STAFF REPORT 07-24-2019 SPECIAL MEETING

APPLICATION NUMBER: 19-6332 **ADDRESS:** 500 TEMPLE AVENUE **HISTORIC DISTRICT:** CASS PARK

APPLICANT: DAWN BILOBRAN, 313 HISTORIC PRESERVATION FOR MASONIC TEMPLE ASSOCIATION

Removal of Existing Marquee:

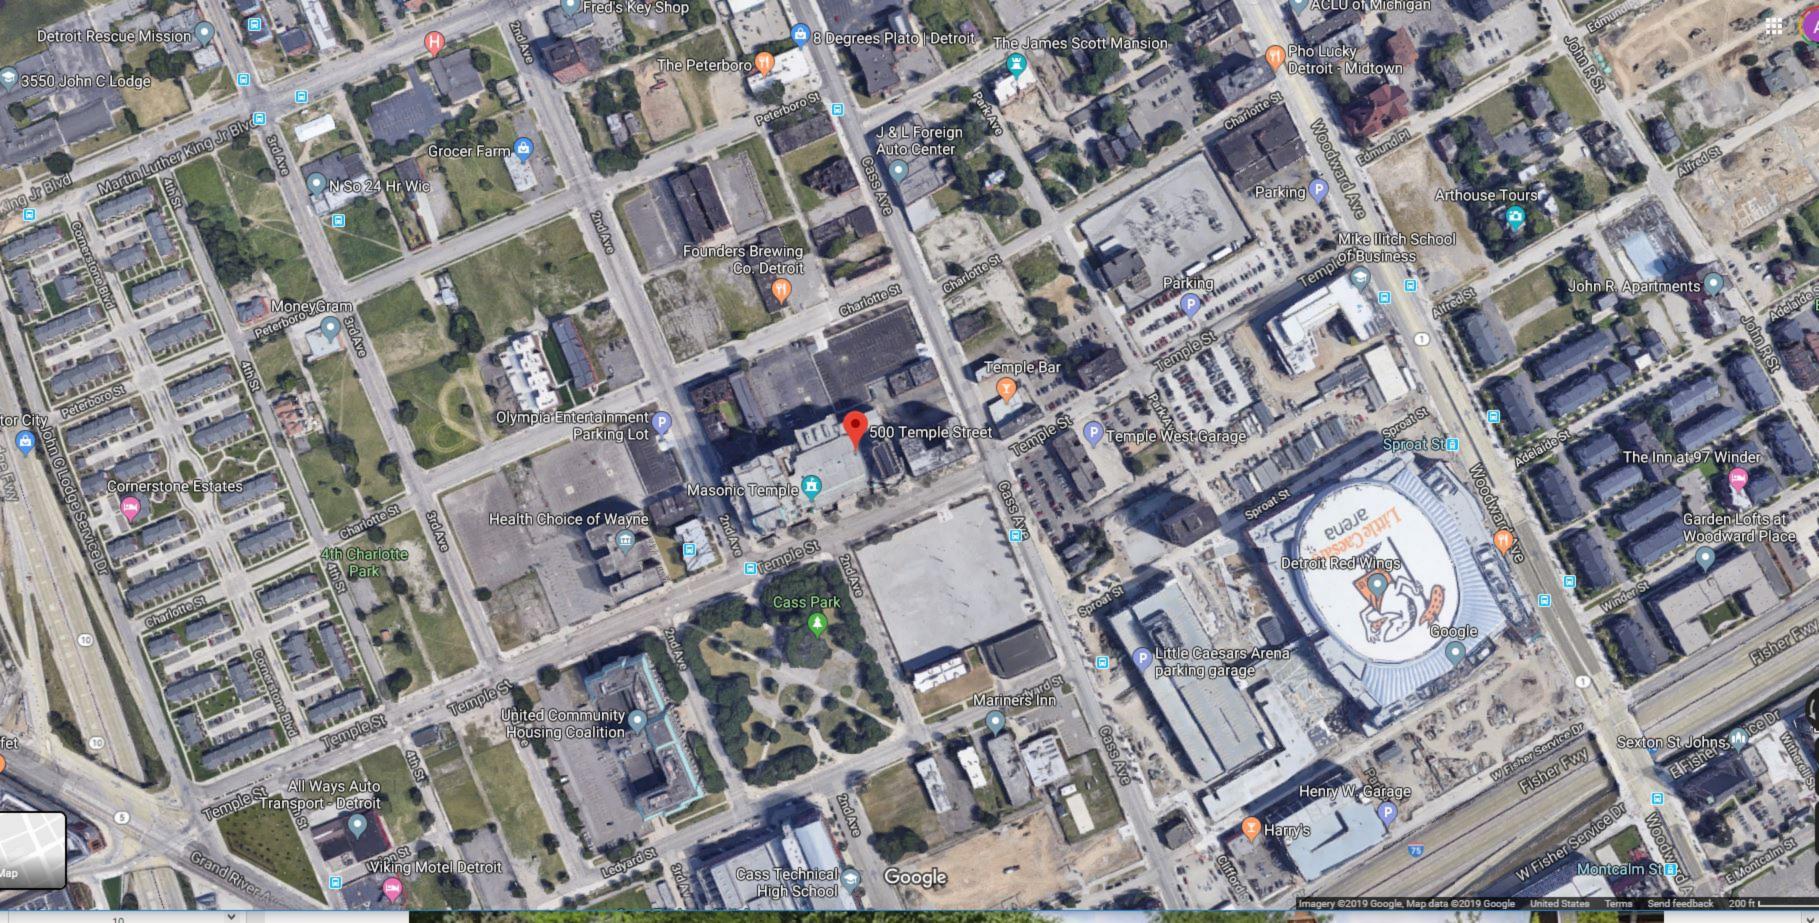
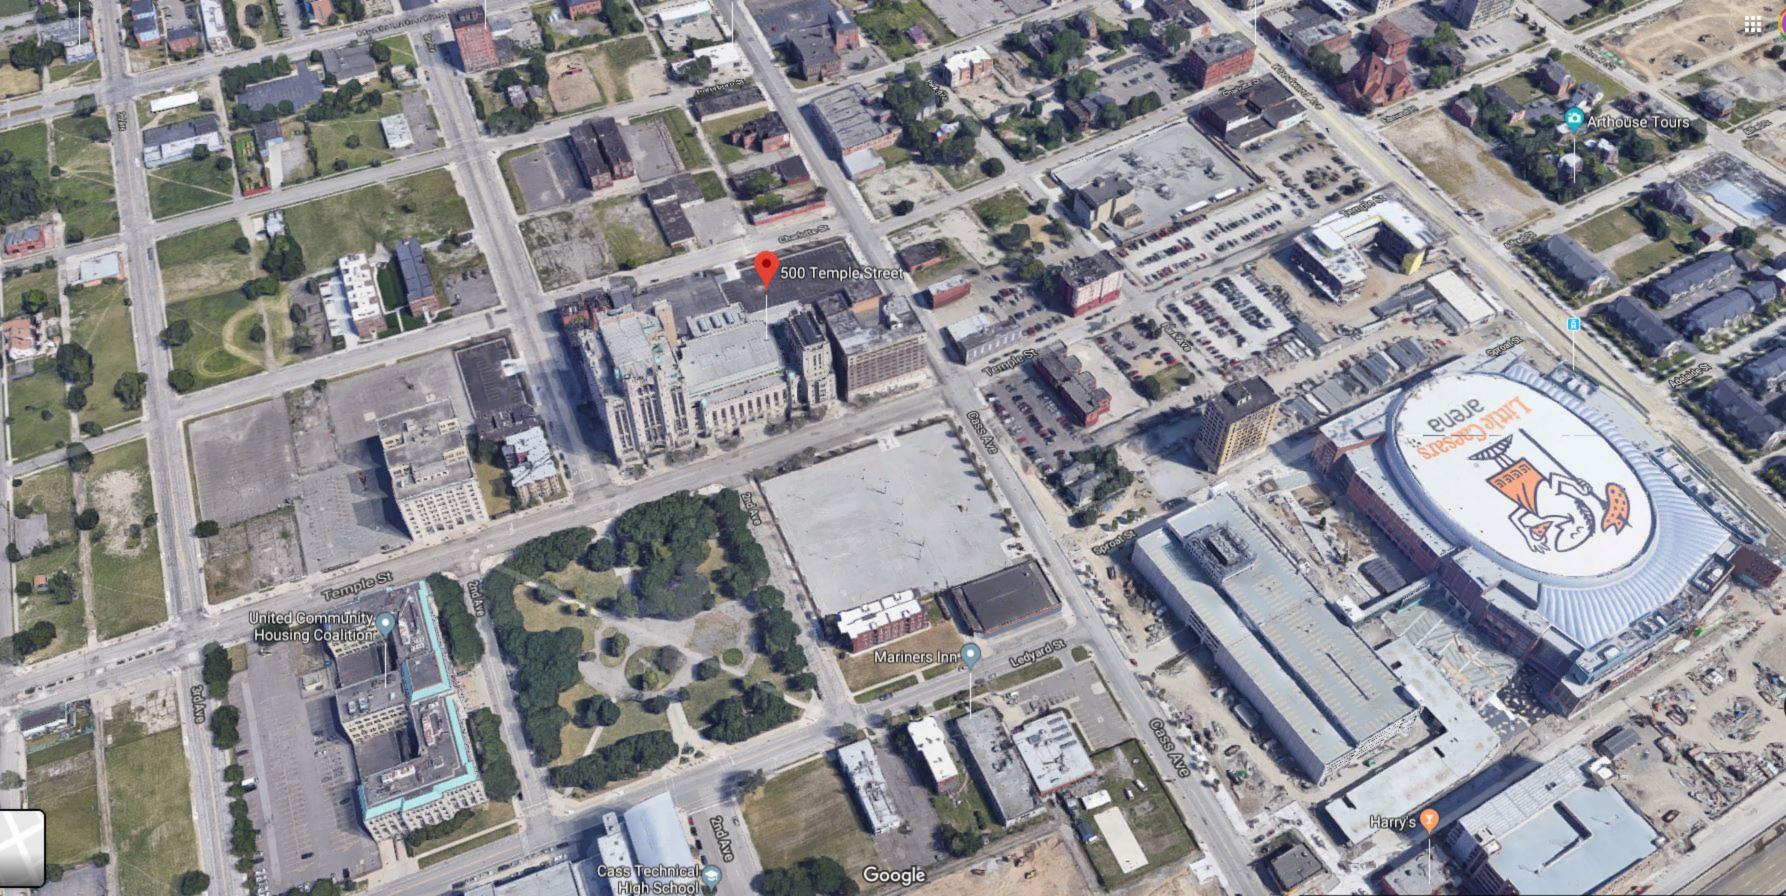
It is staff's opinion that the proposed removal of the existing marquee signage will not destroy historic materials that characterize the building, its site, or setting. Staff therefore recommends that the Commission find the proposed removal of the existing marquee signage to be an acceptable proposal as the work meets the Secretary of the Interior's Standards for Rehabilitation

Existing Marquee Sign 120 SF

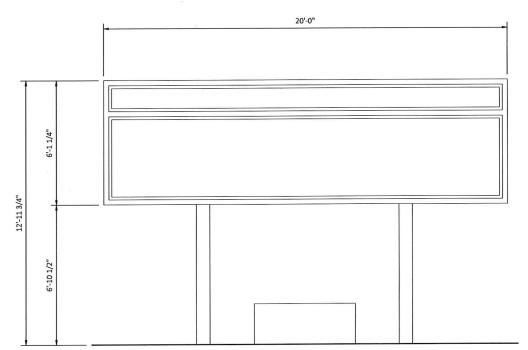
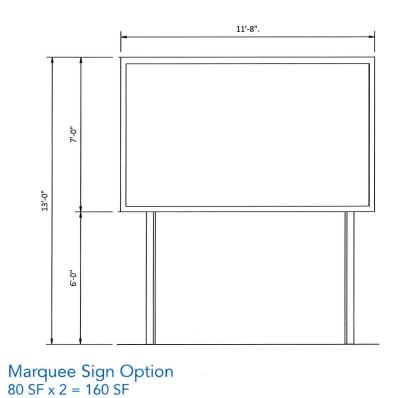
- The existing sign is not considered to be a character defining feature of the historic building, its site, or setting.
- The proposed sign does not conform to the Commission's Sign & Awning Guidelines (see document attached).
- The proposed sign is significantly larger and taller than the existing. The bottom of the proposed sign will be 9' above grade (existing sign is 6'-10" above grade) with the top of the proposed sign finishing at 15'-5" above grade (existing sign finishes approximately 13' above grade)

Simulated Front View

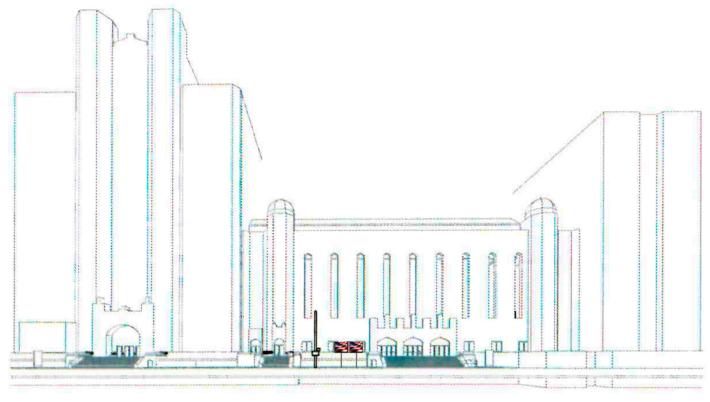
It is staff's opinion that the proposed digital LED marquee detracts from the historic building, its site, and urban pedestrian setting. Staff therefore recommends that the Commission find the proposed marquee signage to be inappropriate as the work does not meet the Secretary of the Interior's Standards for Rehabilitation
